EVOLUTION PLANNING

20 June 2025

RE: SSD-81623209– RESIDENTIAL DEVELOPMENT, 9-21 BEACONSFIELD PARADE, LINDFIELD.

Figure 3: Extract North Elevation facing Newark properties.

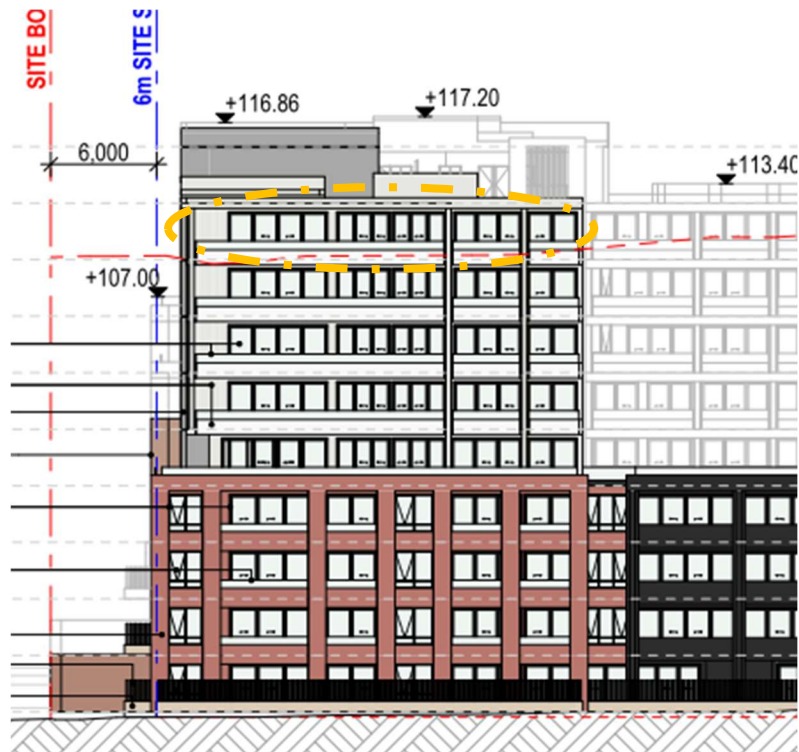
(g) – The parts in breach of the standard do not only relate to lift over runs and roof open space. The elevations and sections clearly show north facing apartments in breach of the height limit by between ½ and 1 storey. Refer to Figure 3 below.

This is not correct. Refer to the extracts below from part of the non-compliant north elevation and section showing apartment windows facing the Newark properties located above the height limit.

Figure 4: Extract DA302 Section at northern part of building adjacent to the Newark properties.

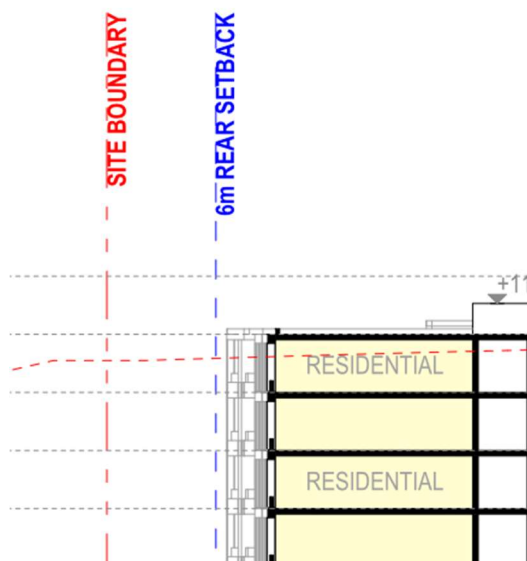
A section drawing through the eastern end part of the development where the breach is greatest is not provided, but the sections provided, extracted below at Figure 4, clearly show windows in breach of the height limit. The findings stated in the variation request pertaining to an absence of potential privacy impacts is not correct. Direct sightlines will be available from apartments in breach of the standard to the rear private open space areas of the Newark properties.

Figure 6: Extract L3 western building – Cross ventilation analysis DA508

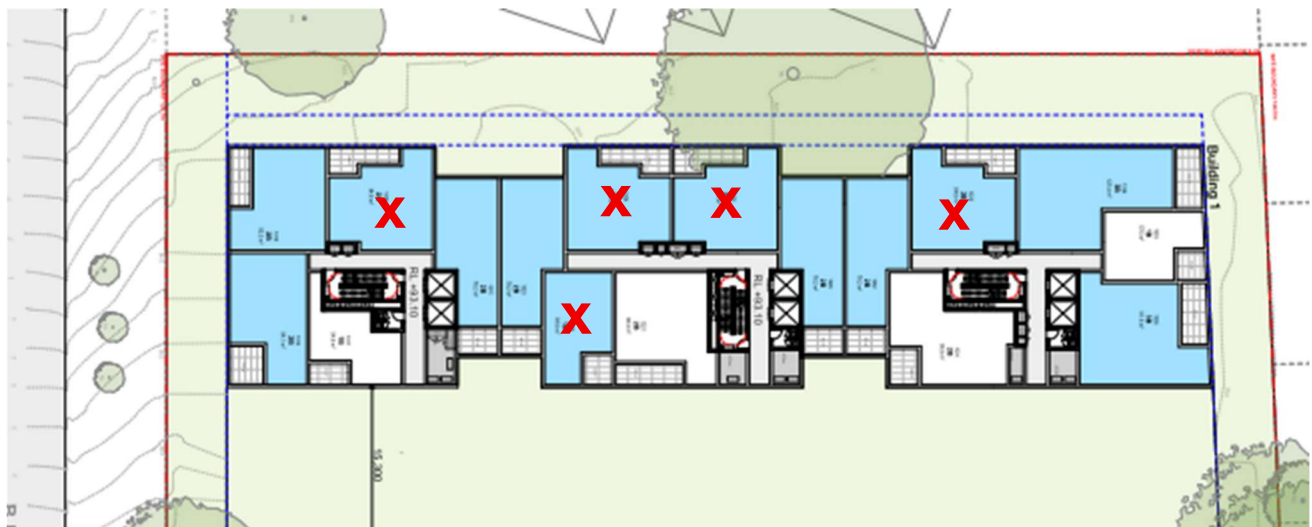
The proposal includes apartments which are single aspect, relying on a recessed plane introduced by a window or balcony, which are specifically excluded in the ADG as shown above. Refer to Figure 6 below for a limited analysis of Level 3 only, but the anomaly is repeated throughout. The proposal does not comply to a significant degree.
